Addendum No. 1
February 23, 2023

FHS – SHOSHONE,
IDAHO

The following items contain additions, deletions, or modifications to the Plans and Specifications. This Addendum forms a part of the Contract Documents and shall be bound inside the cover of the Project Manual.

1 SITE - GARBAGE/RECYCLE ENCLOSURE
1/2" = 1'-0"

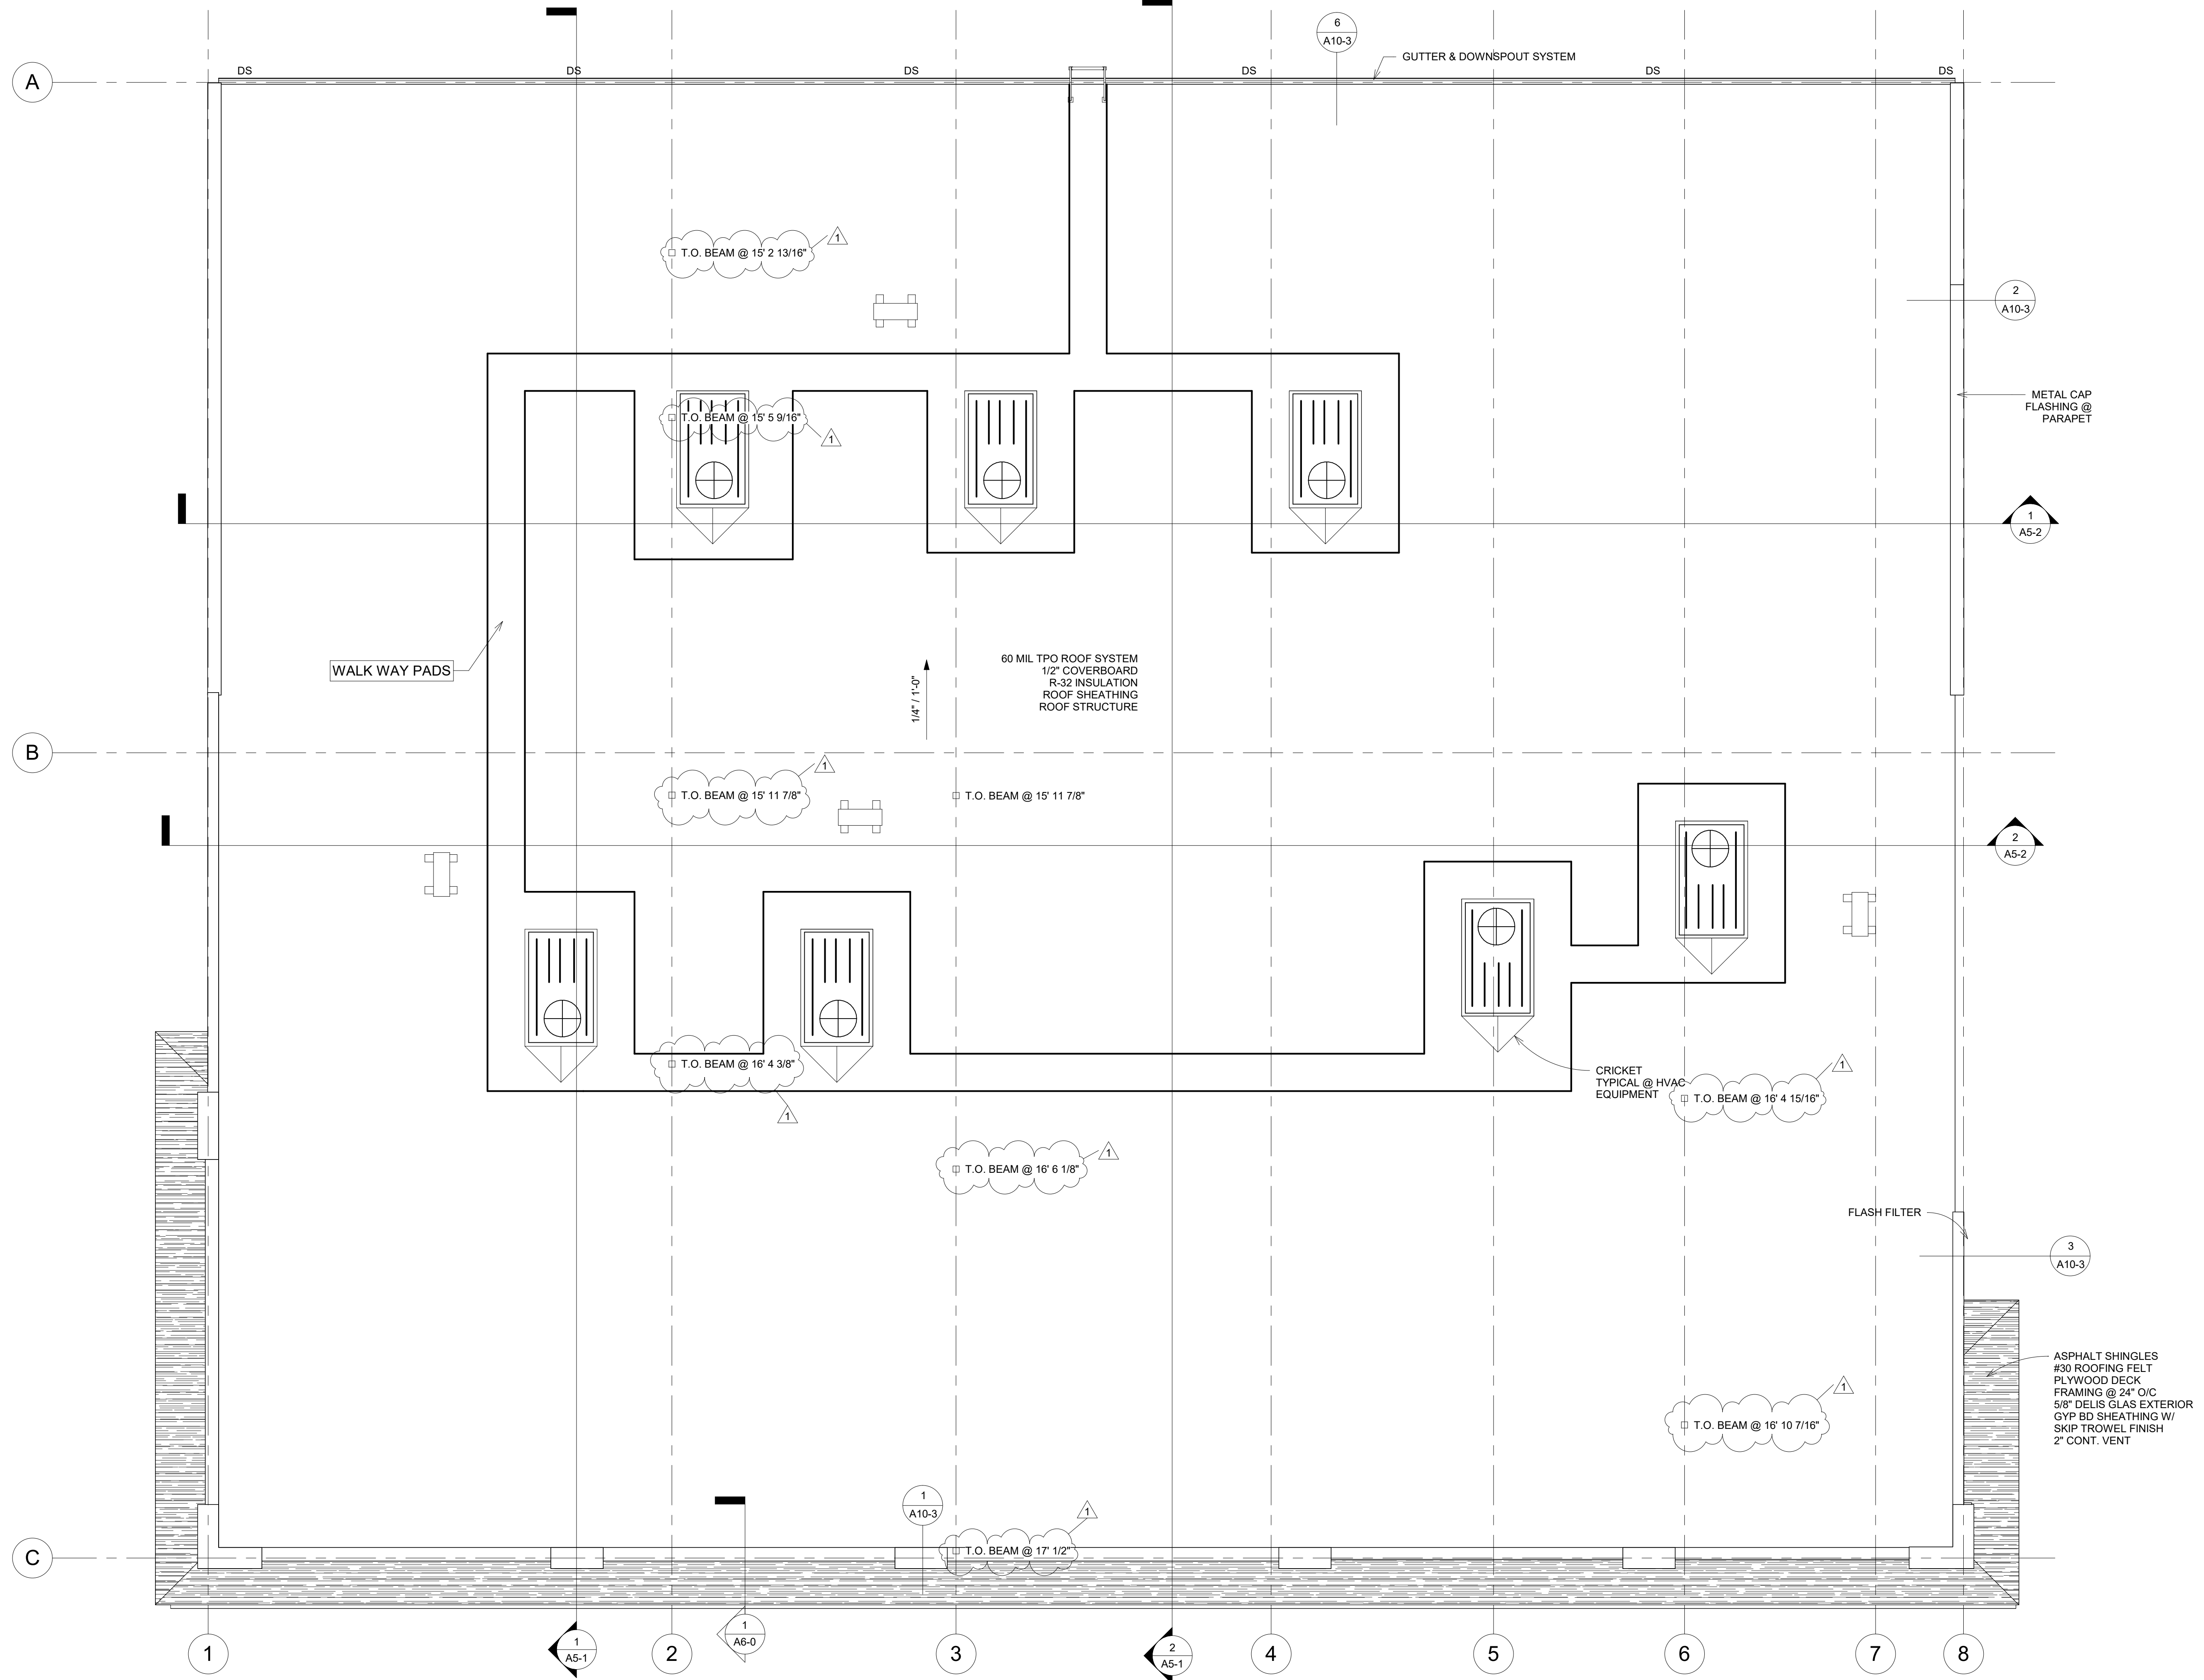
Sheet A0-0 revised sheet index
Sheet A1-0 revised trash enclosure callout to 1, A1-2
Sheet A1-1 revised details per attached
Sheet A1-2 added sheet in its entirety
Sheet A4-1 added top of beam call outs
Sheet A5-2 modified fire wall
Sheet A8-3 modified RR 107 shower
Sheet A9-1 modified finishes for RR 107
Sheet A10-3 Detail 6 revised per attached

A NEW FACILITY FOR:
FAMILY HEALTH SERVICES
 SHOSHONE, IDAHO
CIVIL UTILITY AND STORM DRAIN PLAN

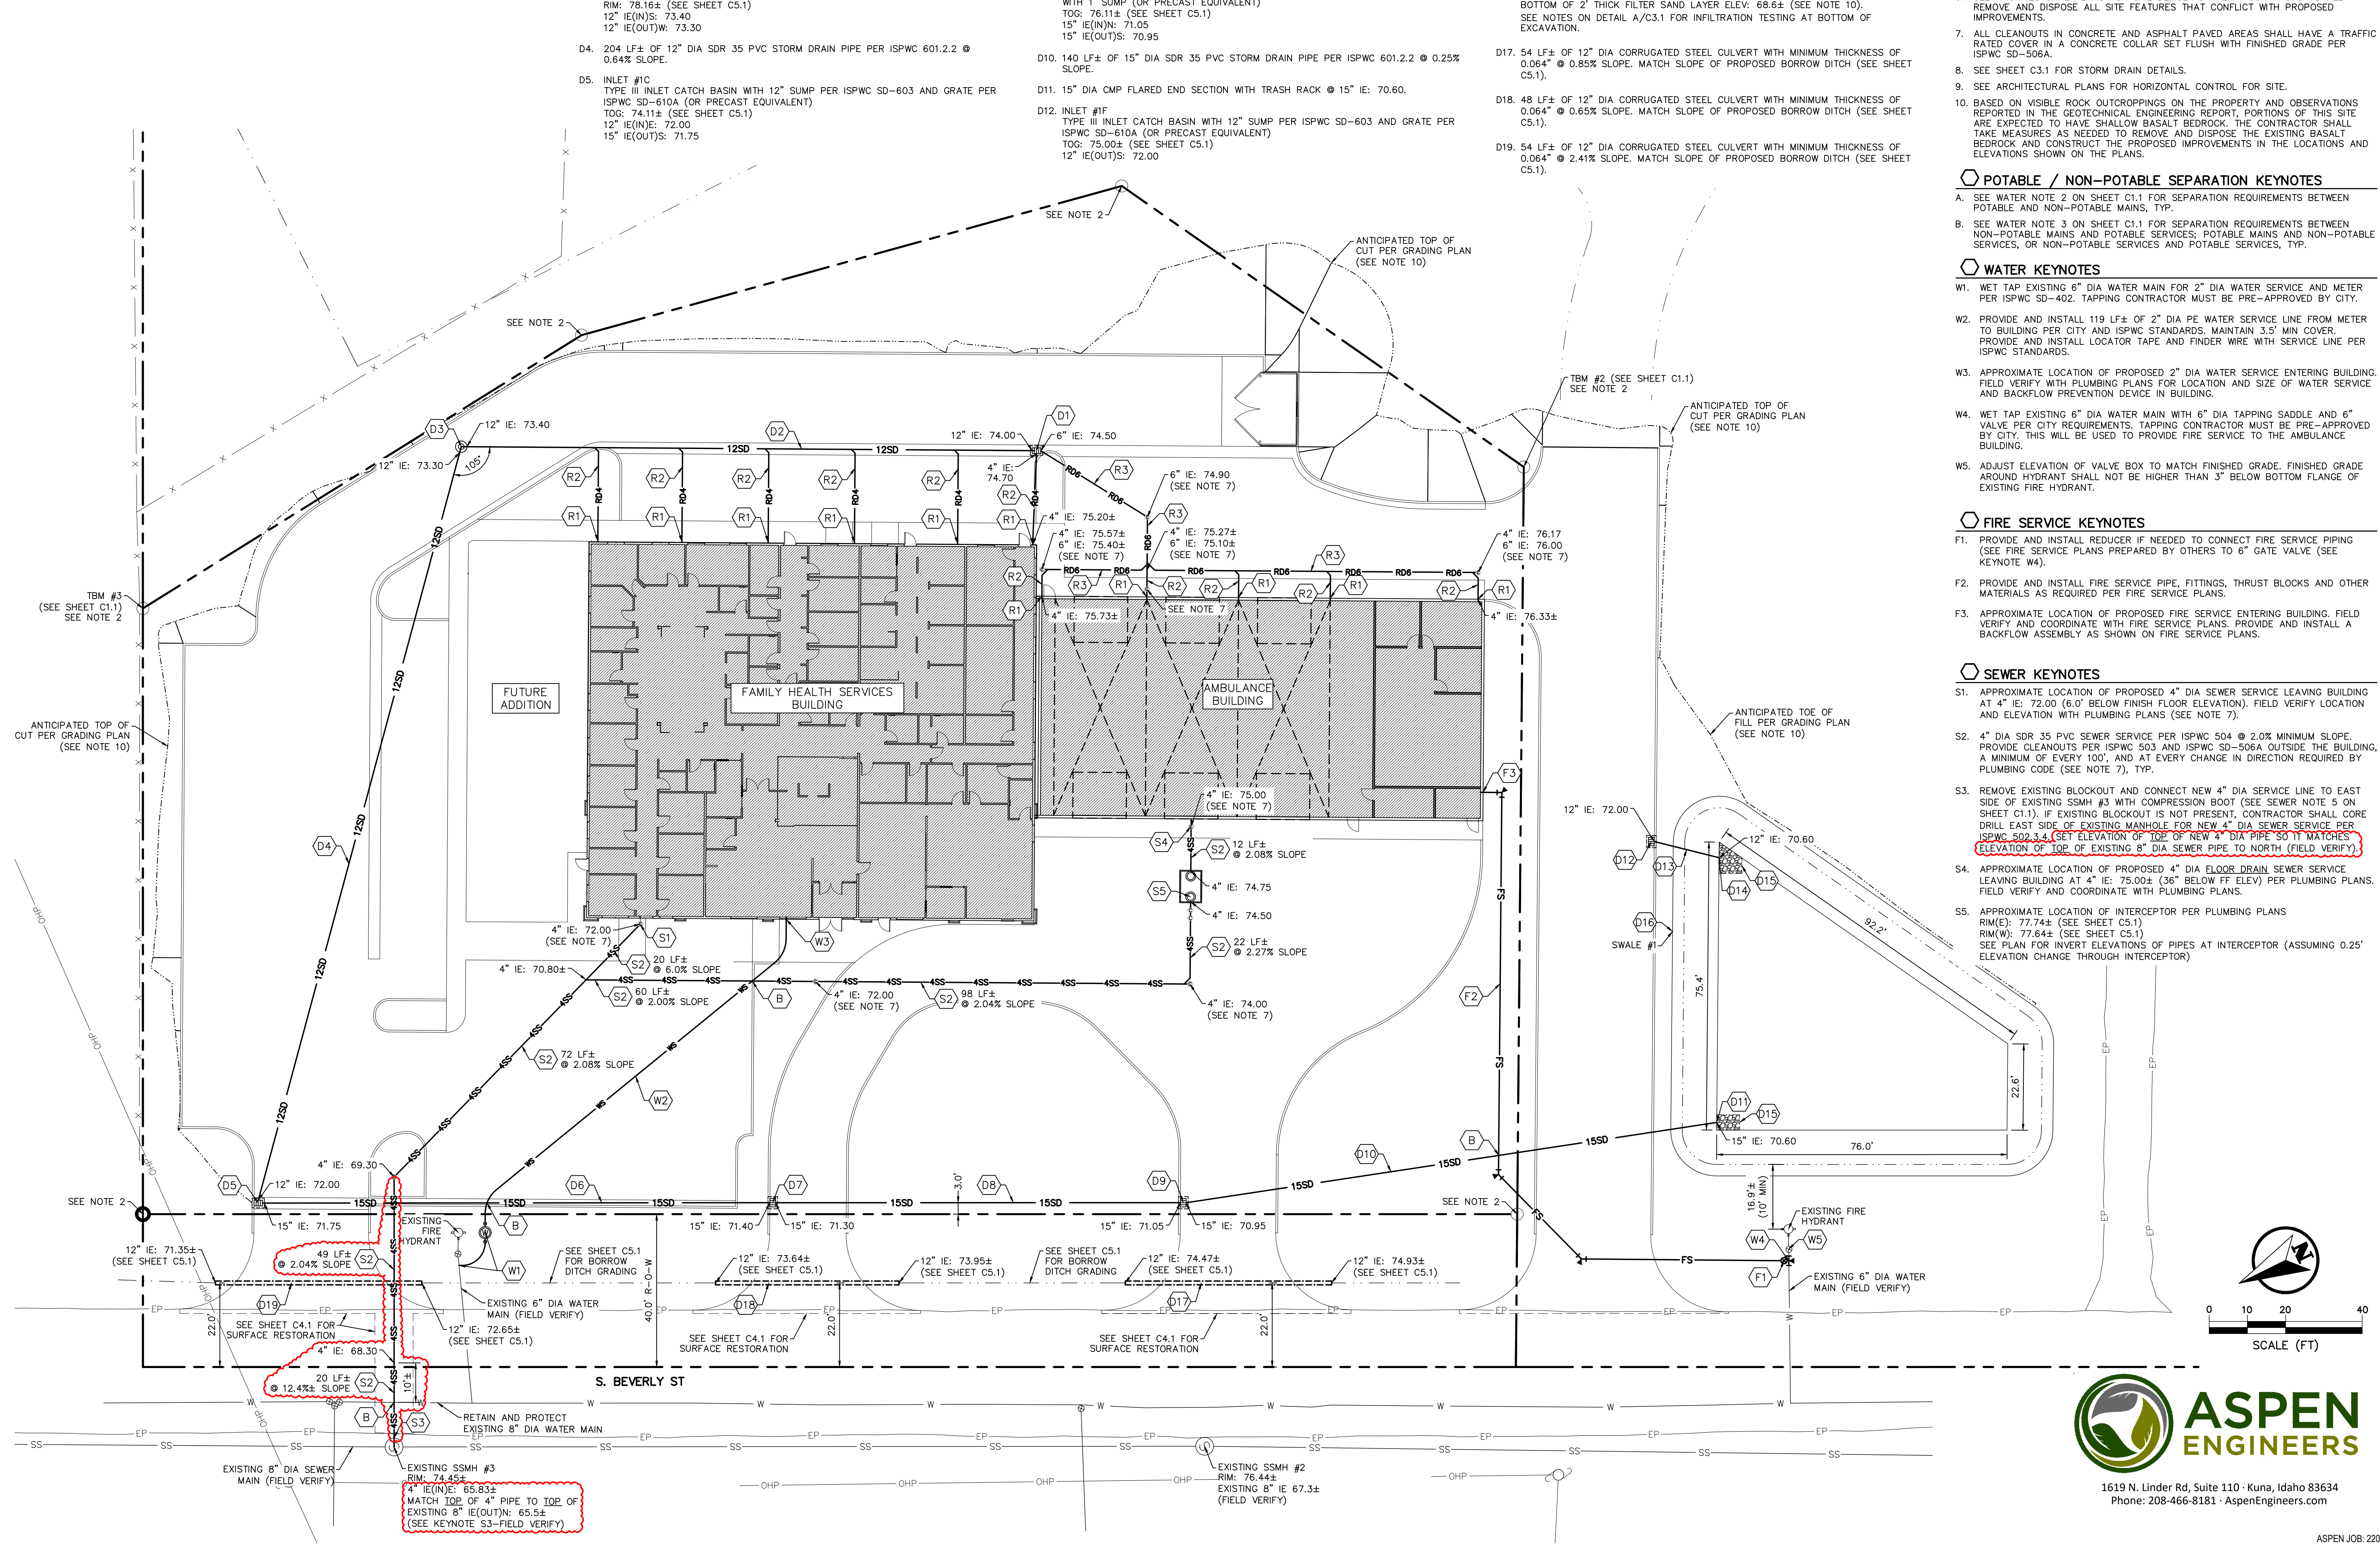
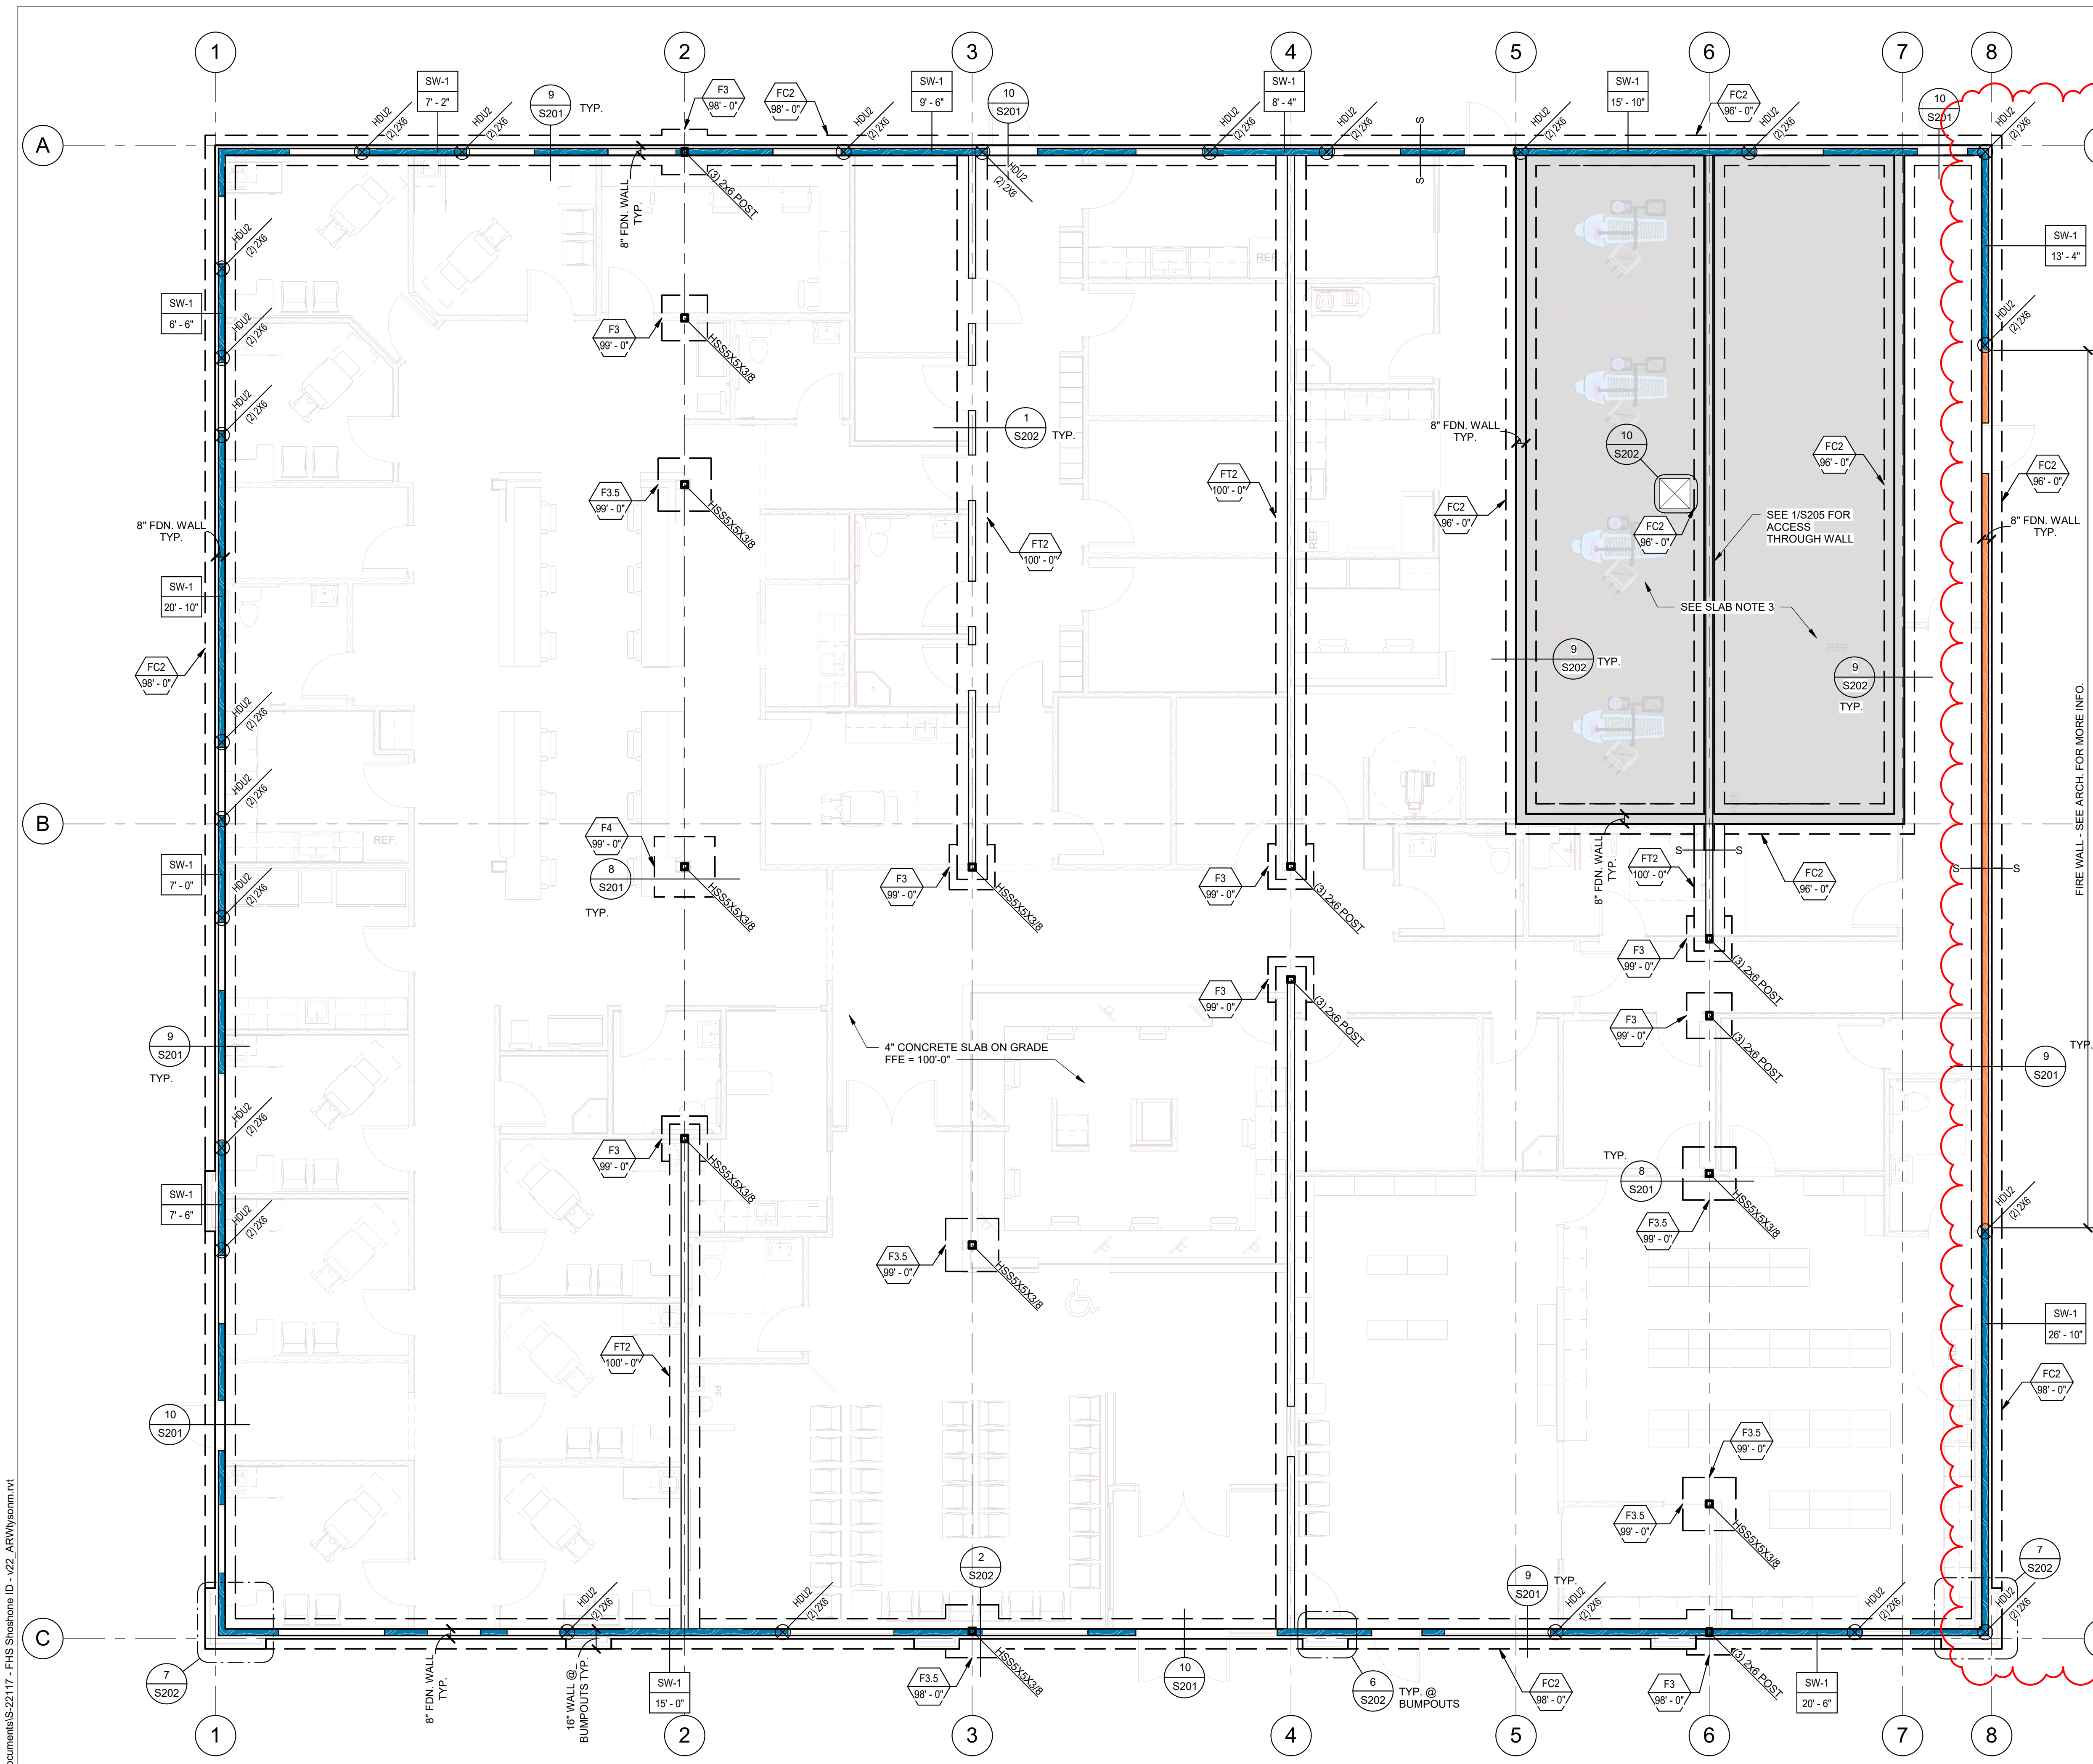
Sheet C2.1 modified per city comments
